Project	IEEE 802.16 Broadband Wireless Access Working Group < http://ieee802.org/16 >	
Title	Clarification on vertically encoded MIMO	
Date Submitted	2005-01-21	
Source(s)	Qinghua Li, Xintian Eddie Lin, Ada Poon, Alexei Davydov, Nageen Himayat, Minnie Ho, Sumeet Sandhu, Uri Perlmutter, Yuval Lomnitz, Randall Schwartz, Jose Puthenkulam Intel Corporation	qinghua.li@intel.com Voice: +1-408-765-9698
Re:		
Abstract		
Purpose	Adoption of proposed changes into P802.16e Crossed out indicates deleted text, <u>underlined blue indicates new text change to the Standard</u>	
Notice	This document has been prepared to assist IEEE 802.16. It is offered as a basis for discussion and is not binding on the contributing individual(s) or organization(s). The material in this document is subject to change in form and content after further study. The contributor(s) reserve(s) the right to add, amend or withdraw material contained herein.

Clarification on Vertically Encoded MIMO

Abstract

Figure 1 Exemplary structure for vertically encoded MIMO in D5a.

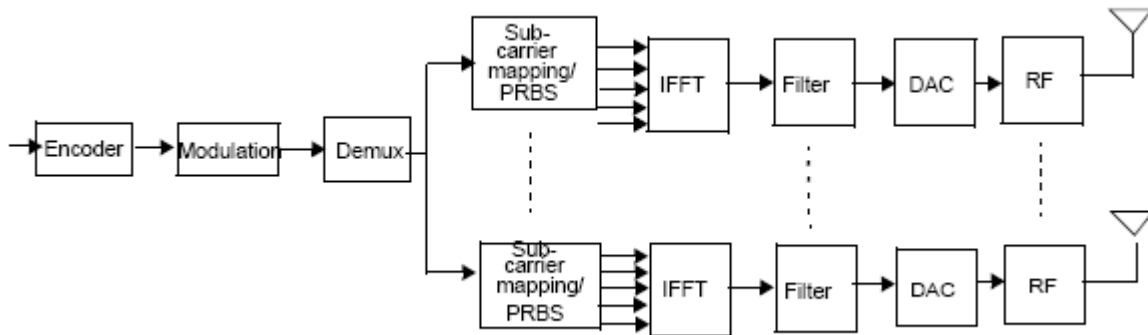
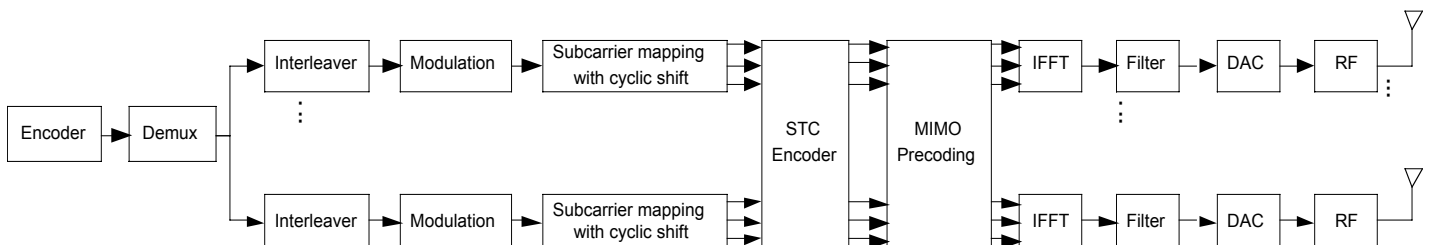
On page 336, D5a, there is an exemplary figure for vertically encoded MIMO, which is shown in Figure 1. The major disadvantages of this structure are as follows. First, new interleavers are needed to be defined for the increased payload sizes due to parallel spatial channels. For example, the interleaver size at the output of encoder needs to be doubled for two spatial channels. Second, frequency diversity is not maximized because the subchannel allocation for each spatial stream is the same. For example, one FEC block is interleaved and mapped into QAM symbols. The QAM symbols are alternately assigned to two subchannel blocks on two spatial channels by the demux. Because the subchannel allocation is exactly the same on both spatial channels, both subchannels are on the same subcarriers. This means that the FEC block is placed on the same physical subcarriers on both spatial channels. This limitation reduces the frequency diversity if the subchannel doesn't occupy all subcarriers allocated for the user. Frequency diversity can be improved by allowing the logical subchannels on different spatial channels to be placed on different sets of physical subcarriers. Finally, the structure in Figure 1 doesn't support adaptive bit loading because all code bits are mapped to the same modulation constellation before demux. The performance of closed loop is maximized when different modulation orders are employed for different spatial streams. The signal qualities on spatial channels can be different by more than 9 dB, which can not be compensated by FEC codes, and the weakest spatial channel dominates the performance although there is excess signal power in the strong spatial channels.

We propose slight modifications of the structure in Figure 1. The new structure supports open loop, closed loop, UBL, and ABL, as shown in Figure 3. It doesn't need to define new interleavers for MIMO and employs legacy interleavers designed for single-input single-output systems. The demux in Figure 1 is enhanced to support ABL and a cyclic shift is added at subcarrier mapping block to maximize frequency diversity. The transmitter works as follows. A block of data bits is first encoded by FEC encoder and the code bits are punctured to achieve a specified code rate. The punctured code bits are distributed to multiple streams according the modulation orders selected for the spatial channels. The distributed bits are interleaved by a legacy interleaver on each channel. The interleaved bits are mapped to QAM symbols and the QAM symbols are mapped to logical subcarriers. The QAM symbols on the logical subcarriers are circularly shifted by $j - 1$ subcarrier for the j -th channel for $j = 1, L, M$. The circular shift allows the physical subchannel allocations on different spatial channels to be different so that frequency diversity is maximized. After the shift, the QAM symbols are STC encoded and may be beamformed and are finally sent. Detailed operations of the demux is depicted next.

Figure 3 Proposed structure for vertically encoded MIMO.

The demux extracts bits for M spatial channels one by one in descending order of the channels' modulation order. It first evenly extracts the bits for the spatial channel with the greatest modulation order from the input bit sequence. Namely, the i -th extracted bit is the k -th bit in the original input bit sequence, where

Figure 254a Illustration of vertically encoding for optional zones in DL.

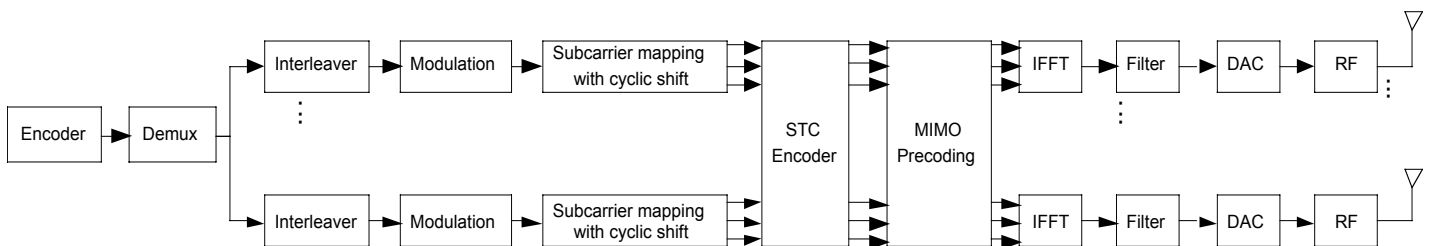
Added section 8.4.8.10 at line 33 on page 362 of [1] as follows

Figure 254a illustrates a transmitter for vertically encoded MIMO, where there are M data streams. The punctured code bits are distributed into M modulation chains by the demultiplexer. The demultiplexer extracts bits for the chains one by one from its input bit sequence. The bits to the chain with higher modulation order are extracted before those with lower modulation order. Denote the number of bits per subcarrier on the j -th chain as L_j , where $L_1 \geq L_2 \geq \dots \geq L_M$. The demultiplexer first extracts the bits for the chain with the greatest modulation order from as follows. The i -th extracted

bit is the k -th bit in the original input bit sequence, where $k = \text{round}\left(\frac{i}{L_1} \sum_{j=1}^M L_j\right)$. For the p -th chain, the i -th extracted

bit is the k -th bit in the remaining bits after the extractions for the previous $p-1$ chains, where $k = \text{round}\left(\frac{i}{L_p} \sum_{j=p}^M L_j\right)$.

Each chain interleaves and modulates the distributed bits using the interleaving schemes specified for SISO transmission. After mapped to logical subcarriers, the modulated symbols are circularly shifted by $j-1$ logical subcarriers for the j -th chain for $j = 1, 2, \dots, M$.
